APPENDIX N. PUBLIC COMMENT LETTERS AND RESPONSES

Appendix N-1: 2024 Plan Public Comment Letters and Responses

RE: Kern County Subbasin May 2024 Draft Groundwater Sustainability Plan - Subsidence

RE: Response to Western State Petroleum Association (WSPA) Comments Dated August 29, 2024, on the May 2024 Draft Groundwater Sustainability Plan (GSP), Kern County Subbasin, Related to Land Subsidence.

2019 California Aqueduct Plates MP 195-215

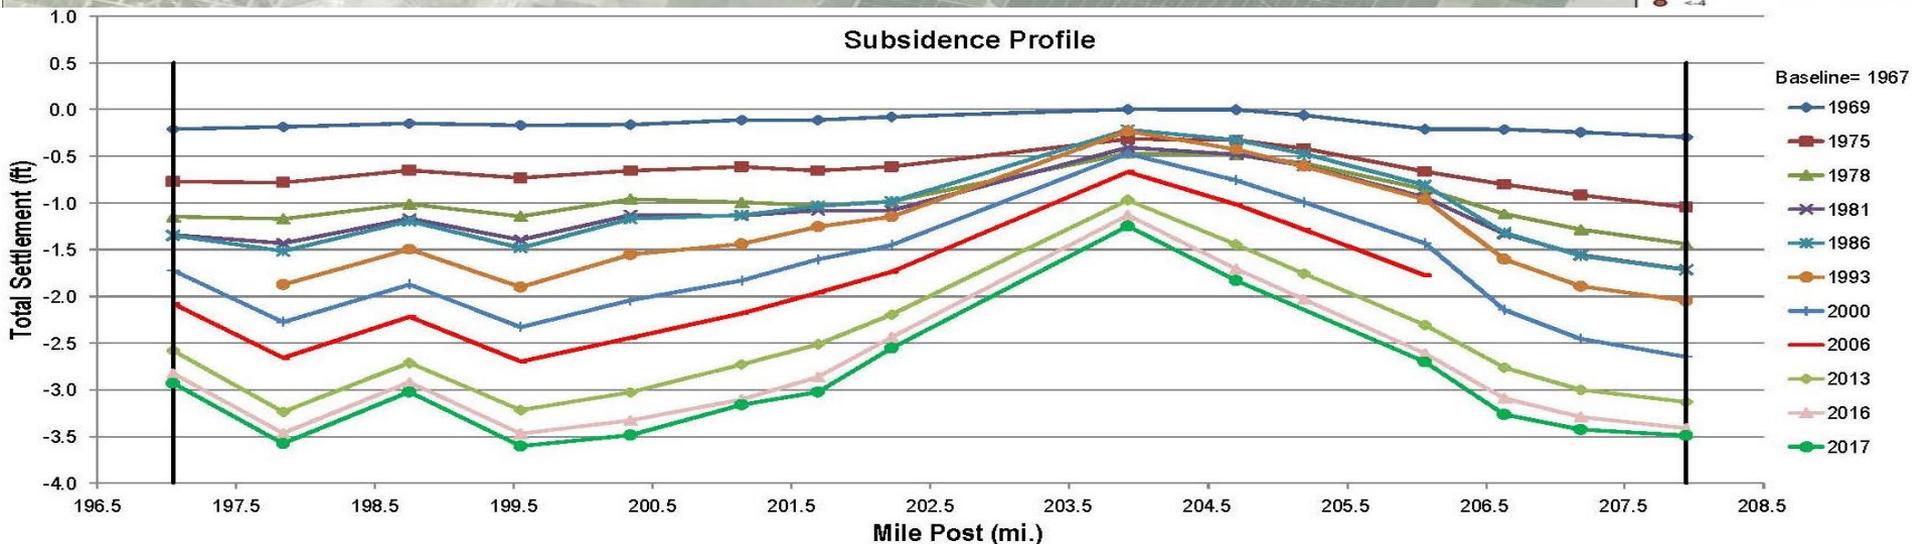
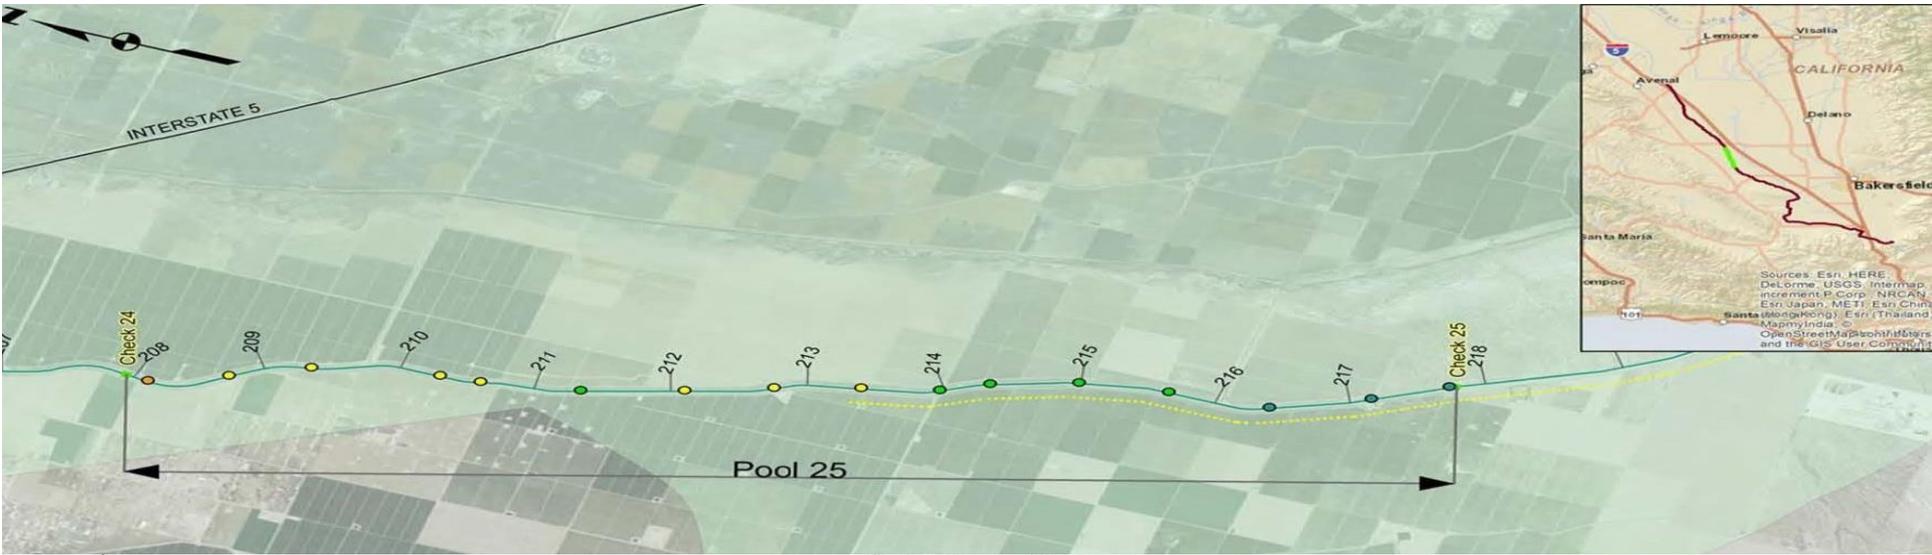
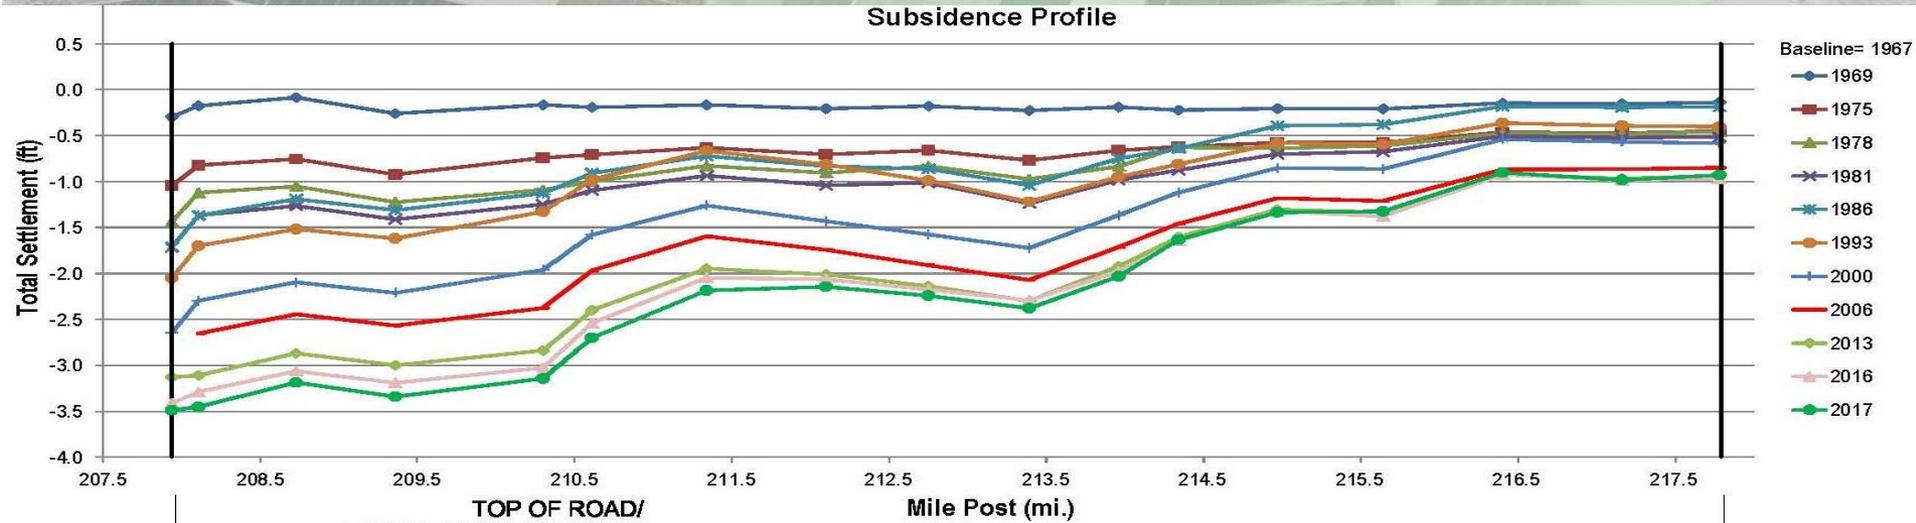
As noted in Response to **Comment # 5**, the DWR *2019 California Aqueduct Subsidence Study: Supplemental Report*, land subsidence survey profiles provided on Plates 12 through 14 (**Appendix D**) of this response letter) show that significantly increased rates of subsidence correlate to the beginning of Lost Hills Oil Field activities at approximately MP 195 and extend along the Lost Hill Oil Field to approximately MP 215 where oil activities currently end or are reduced. In regard to WSPA’s comment that, “*the California Aqueduct Subsidence Study: Supplemental Report, relying on several lines of evidence (including an expanded 5 mile buffer zone on either side of the Aqueduct), concluded that, “subsidence associated with oilfield operations in the Lost Hills area is localized to the Lost Hills Oilfield and does not extend to the Aqueduct with subsidence background rates west of the Aqueduct”*”, new data show otherwise. In fact, CASP, in their December 21, 2023, response letter to WSPA state, “*These studies [the 2017 California Aqueduct Subsidence Study and the subsequent 2019 supplemental California Aqueduct Subsidence Study] contributed to the body of knowledge of subsidence along the Aqueduct. However, given the limited data and information on which these studies were based, it is important that the interpretations they contain not be viewed as the definitive 'end of the story,' but rather an important step towards a collective understanding of the causes of subsidence affecting the California Aqueduct.*” (emphasis added)

Figure 8-71. Time Series for AOI-5 Track H-H'

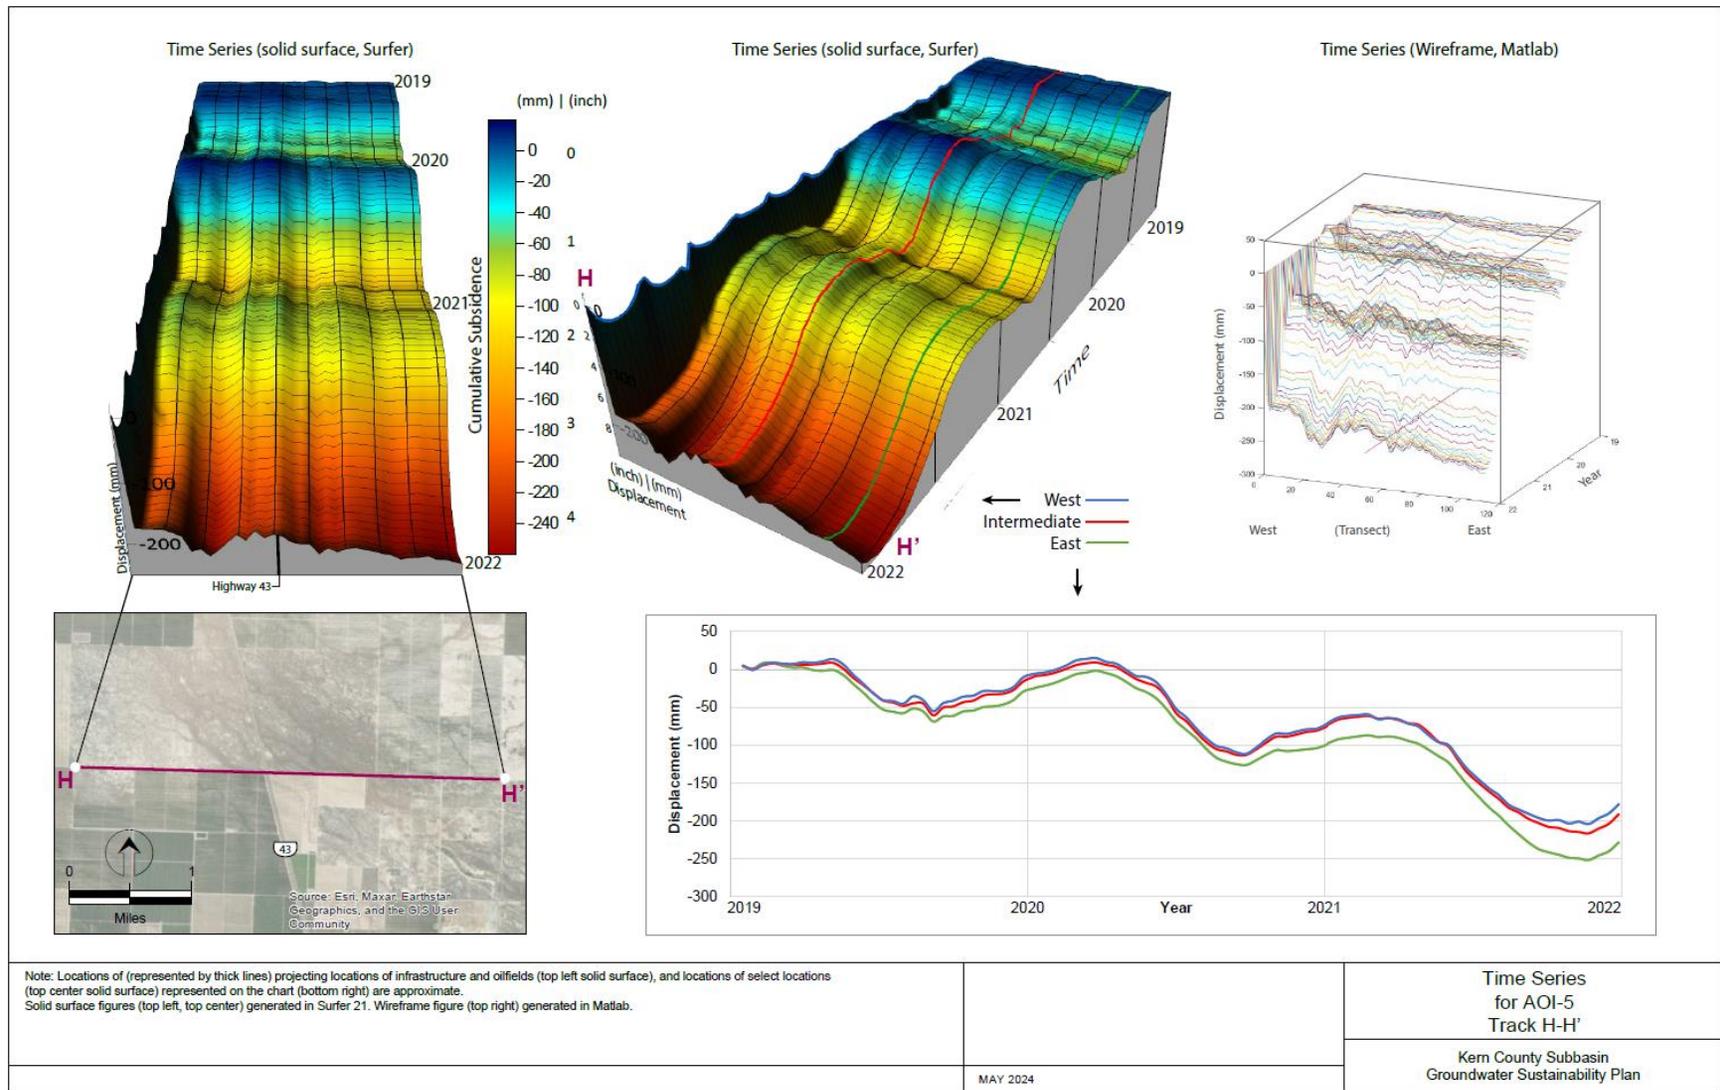
In the Subbasin 2024 Draft GSA Report, **Figure 8-71** provides an example of the InSAR time series signature for agricultural pumping (i.e., GSA-related). In this time series all the time series lines are in harmony and have a sine-wave shape indicative of seasonal pumping activities. Non-seasonal pumping, for example oilfield activities near Aqueduct MP 204, tend to exhibit a less sinuous pattern (i.e., noisy pattern) and a steeper declining slope reflecting non-seasonal (i.e., more sporadic) pumping. **Figure 8-66** in the 2024 GSP provides an example of a non-GSA time series signal (see also, **(Appendix E)** in this response letter). More detail is provided in Section 8.5 of the Subbasin 2024 Draft GSP Report. Based on the WSPA comment, the Subbasin will review **Section 8** of the Subbasin Draft 2024 GSP to ascertain if we can expand or further clarify the existing text in the Final 2024 GSP.

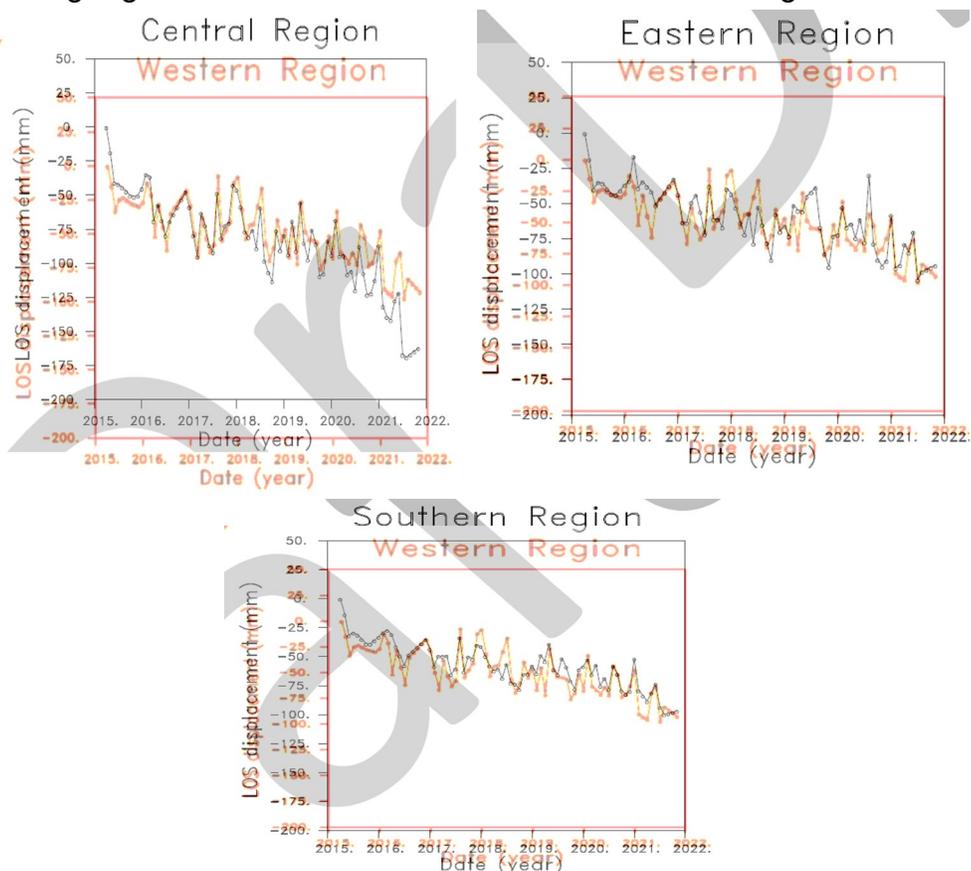
- GSAs’ Response to WSPA Comment #3: In an effort to address the oversight of the ECI 2021 Report³ and the LBNL 2022 Study⁴ —both of which failed to consider oilfield reinjection of produced and make-up water as a means to effectively control localized subsidence—the GSAs cite to the alleged number of wells operating in the LHOFF, apparently in an effort to suggest that such a number of wells induces subsidence. This is an oversimplification that does nothing to address whether the LHOFF is causing subsidence *at the Aqueduct*. Rather, like DWR explained in its 2019 report, at most, the LHOFF operations cause localized subsidence that is limited in scope and does not extend to the Aqueduct, which is greater than 1.0 mile from the operations of WSPA LHOFF

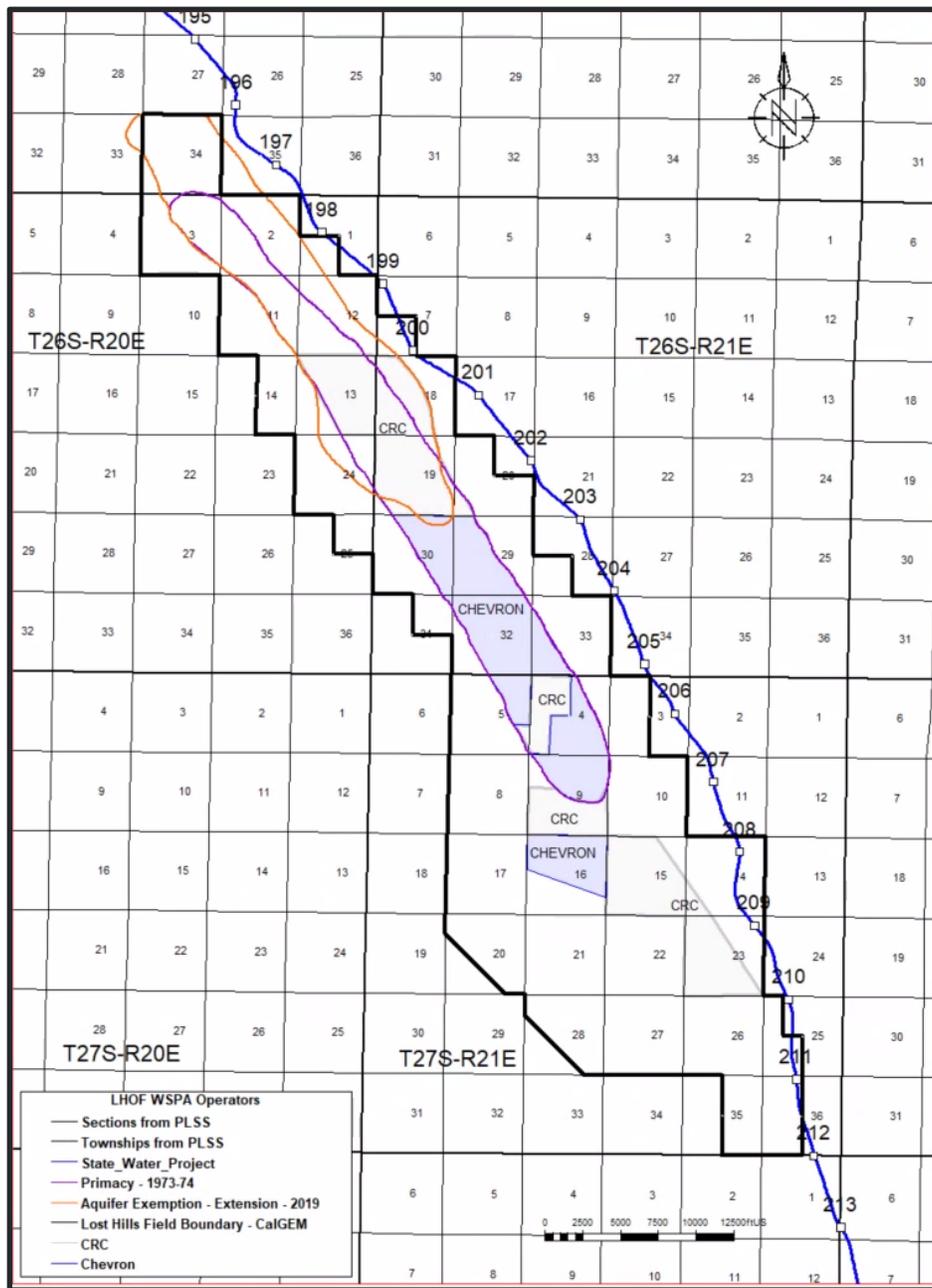
- **GSAs' Response to WSPA Comment #4:** The GSAs' claim that the ECI 2021 Report shows different subsidence trends in the Western Region of the Kern Subbasin than in other regions of the subbasin is belied by the data. Although the actual ECI report has not been publicly released, overlays from figure 4 of the ECI 2021 Report confirm there is little to no difference in the land subsidence signatures between the four regions, indicating that LHOFF operations are not impacting regional subsidence observed in the Western Region.

- **GSAs' Response to WSPA Comment #5:** The GSAs' contention that “subsurface effects of the oilfield extraction propagate up to and outside of the administrative boundaries of the Lost Hills Oil Field including beneath and immediately adjacent Aqueduct” is likewise inconsistent with the data. Rather, subsidence induced by the operations of WSPA operators is localized and does not reach the Aqueduct.

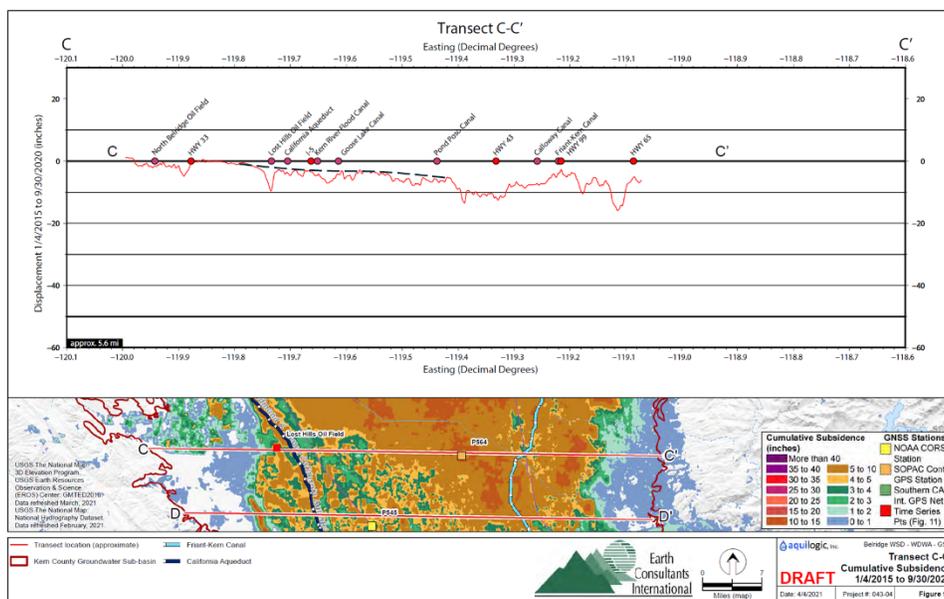
- GSA's Response to WSPA Comment #7: The GSP's focus on the LHOFF administrative boundary as a means to argue that LHOFF subsidence reaches the Aqueduct is misplaced. Where the actual operations occur within the LHOFF—not the administrative boundary—is what matters when considering subsidence. As illustrated in the figure below, WSPA LHOFF operations occur roughly 1.0 mile from the Aqueduct.

- GSAs’ Response to WSPA Comment #9:** WSPA LHOFF operators recognize that their operations cause localized subsidence within the LHOFF. However, analysis of available data confirms that this localized LHOFF subsidence does not extend laterally to the Aqueduct. Moreover, the ECI 2021 Report figure 9c reproduced below identifies a regional subsidence trend throughout the Kern County Subbasin that is caused by activity other than LHOFF operations. The June 2025 GSP fails to consider or discuss this regional subsidence trend or how the trend impacts the GSP’s apparent conclusion that LHOFF activities are responsible for the observed subsidence in the vicinity of the Aqueduct.

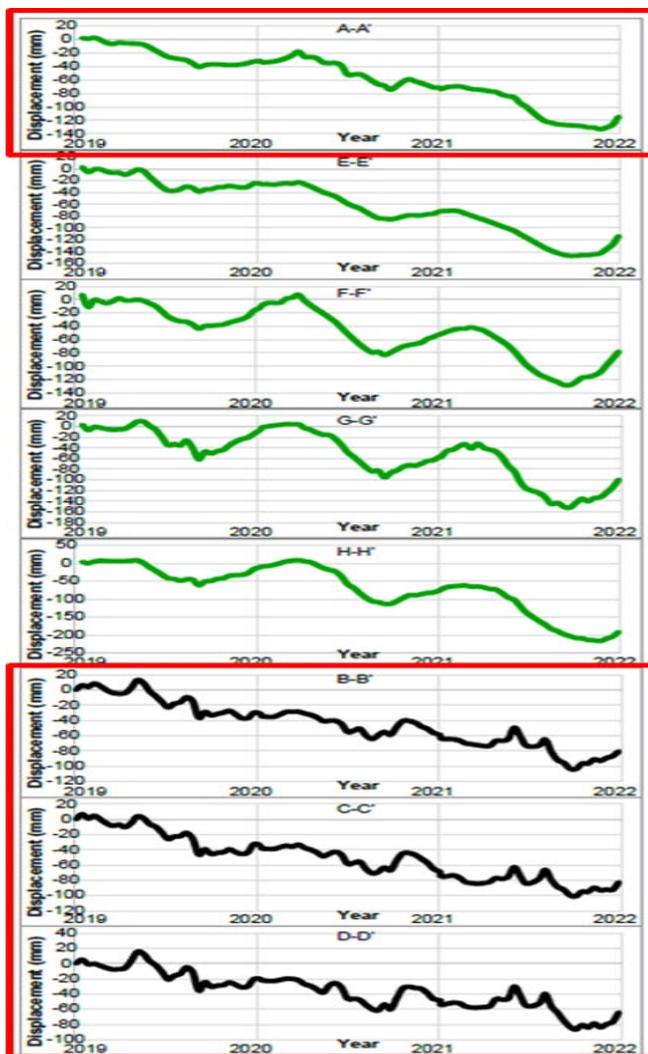
- GSAs’ Response to WSPA Comment #12:** WSPA disputes the GSAs’ conclusion that seasonality observed in curves plotting InSAR land subsidence demonstrate a difference between GSA and non-GSA causes of land subsidence. As an initial matter, three years of subsidence measurement is inadequate to illustrate subsidence characteristics, as illustrated in GSP figure No. 8-83 reproduced below (showing subsidence curves for the three-year period 2019 to 2021). In any event, there is little difference in the land subsidence transect for A-A’ (allegedly showing subsidence associated with agricultural activity) and transects B-B’, C-C’ and D-D’ (allegedly showing subsidence associated with LHOFF oil and gas operations). Land subsidence shows sinusoidal signature in areas where groundwater extraction is the primary source of water for agriculture and crop demand, which is seasonal. Subsidence due to other “GSA factors” does not

necessarily show strong seasonal signatures, depending on crop types and rotation patterns, surface water availability, and other non-agriculture water use.

Note: Modified from Fielding et al. 1999.

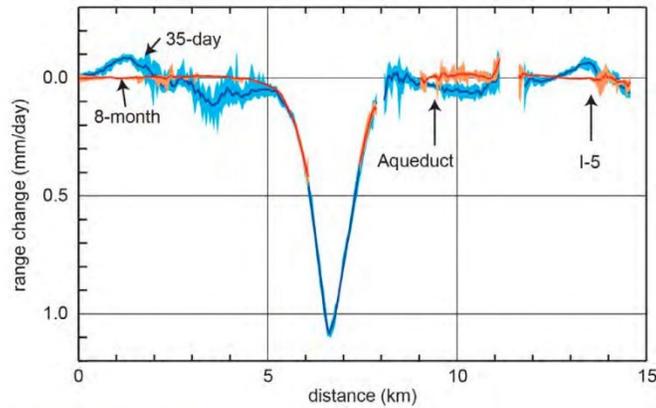
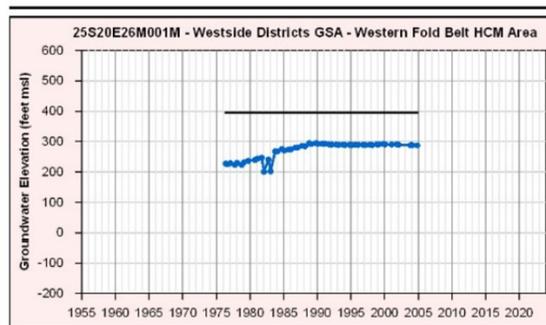
- Unaccounted for Subsidence at and East of the Aqueduct: The June 2025 GSP fails to address another subsidence feature at and east of the Aqueduct, as illustrated in figure 5c in the ECI 2023 Report (reproduced above under GSAs’ Response to WSPA Comment #5). The localized subsidence observed at the LHOFF in Transect C-C’, quickly attenuates before reaching the Aqueduct. However, there is an eastward-increasing subsidence pattern between the end of the LHOFF localized subsidence and the Aqueduct, and this pattern extends east of the Aqueduct, indicating other source(s) of subsidence. A similar phenomenon is observed in the Department of Water Resources March 2019 *California Aqueduct Subsidence Study: Supplemental Report* (CASP 2019 Report),⁶ which

also shows an additional source(s) of subsidence between the LHOFF and the Aqueduct as illustrated in figure 3-3 of CASP 2019 Report as illustrated below.
